TECHNICAL INFORMATION

Date: 06.09.2022
TI: 1522
Type of vending machine: SiLine SÜ

SiLine SÜ product delivery unit

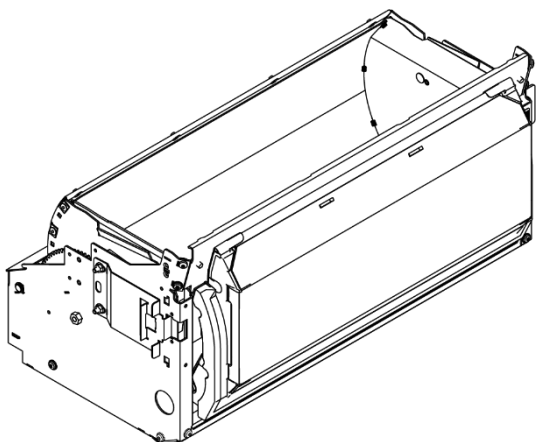
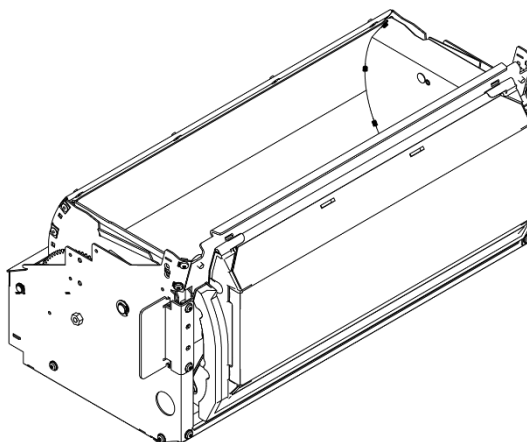
The vending of the SiLine SÜ devices was revised during the course of continuous improvement.

Previous product delivery unit

New product delivery unit

With the introduction of the SiLine Public variants (type RP), the reinforced version of the motorised product delivery unit was taken over into all machines. The advantages are the standardisation of the spare parts and the maximum protection from damage and manipulation – also for “normal” locations.

Because of the change, additional parts need to be installed in the door of the vending machine in devices up to serial number 90503548 (once only). This is because of the new dimensions of the reinforced product delivery unit. The following conversion kits have been created for this:
